Re: Special Permit #57-12
Domenancy, LLC/39-41 Jackson Street

39-41 Jackson Street
Newton, Massachusetts

Proposed Conditions Plan

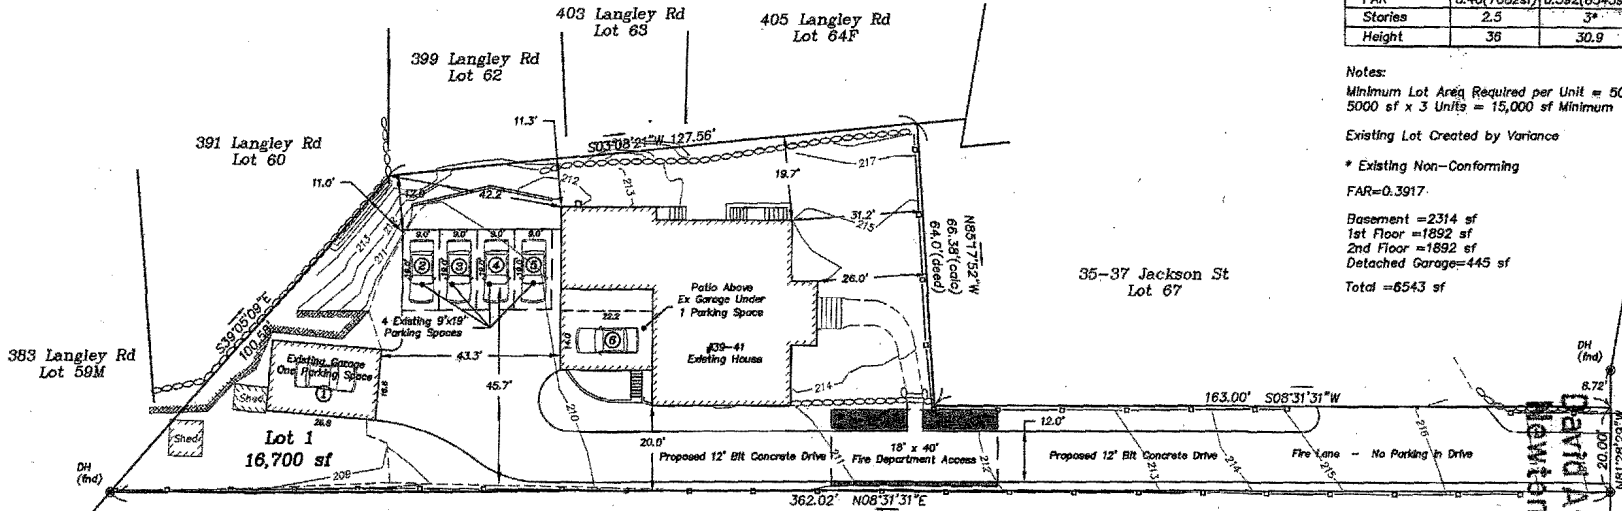
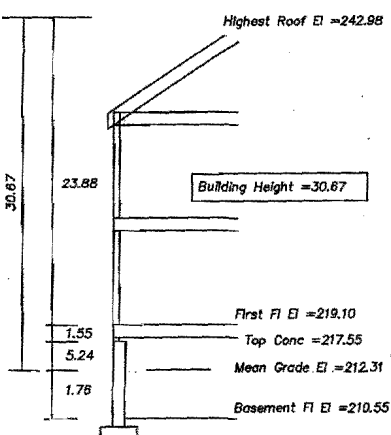
I have enclosed a revised site plan which shows four exterior parking stalls, one parking stall in the attached garage and one parking stall in the detached accessory structure. In effect, we have relocated one parking stall formerly in the attached garage to the outside, resulting in four, as opposed to three, outside parking stalls. The outside parking stalls have been moved slightly to the west so that none of them are within the side setback. The redesign was also accomplished without reducing the open space. The impervious surface for the fourth outdoor parking stall was offset by a reduction of impervious surface in the area formerly within the side setback.
